January 17, 2024

Version 2

Panoramic Glass Roof has a Pop Noise

Supersedes 23-004, dated August 11, 2023, to revise the information highlighted in **yellow**.

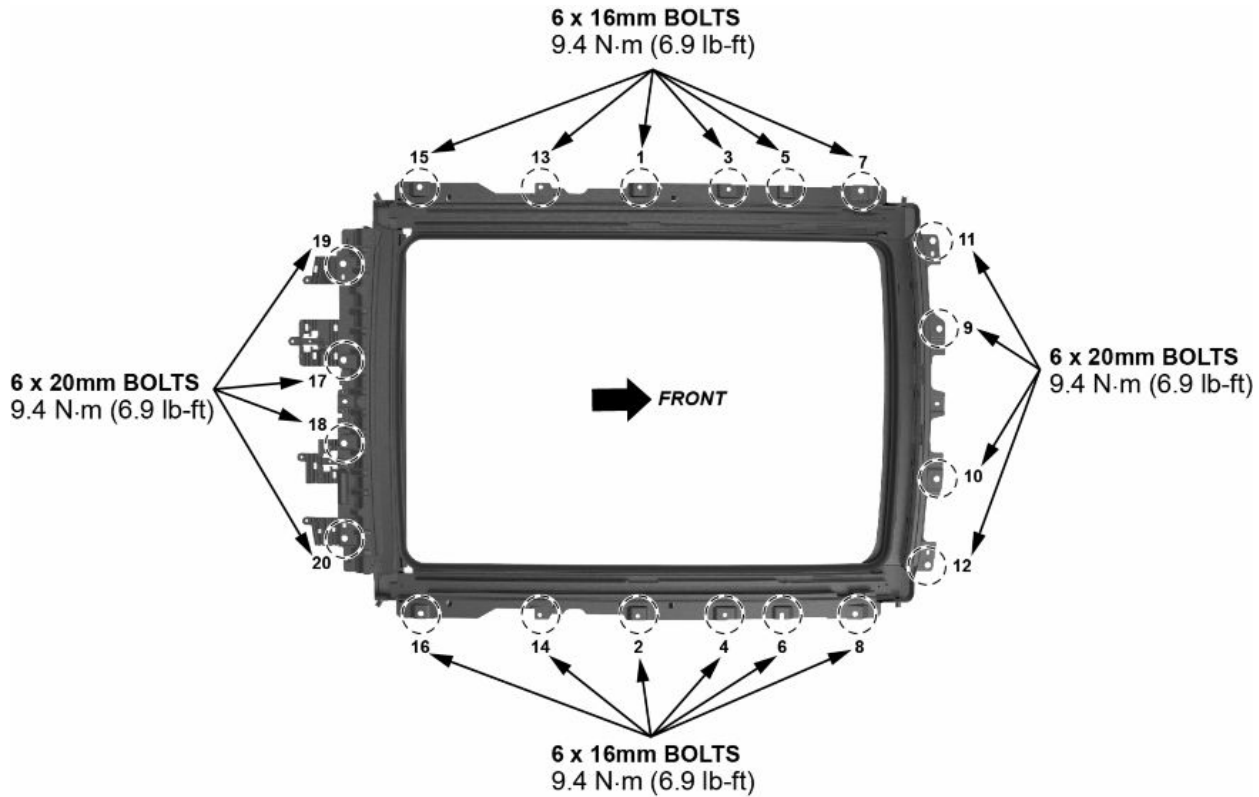
- Under PARTS INFORMATION, garnish clips were added, and the part name and numbers were revised.
- Under REPAIR PROCEDURE, the image was revised.

NOTE: Follow the Service Information procedure; search keyword **Panoramic Glass Roof** > select **Panoramic Glass Roof Mechanical Component Location Index** > select **FRAME: Removal and Installation**. After replacing the frame assembly, follow the torque pattern below. Make sure each bolt is torqued to specification **9.4 N·m (6.9 lb-ft)** during the installation process.

Replace the panoramic glass roof frame assembly. Refer to the Service Information.
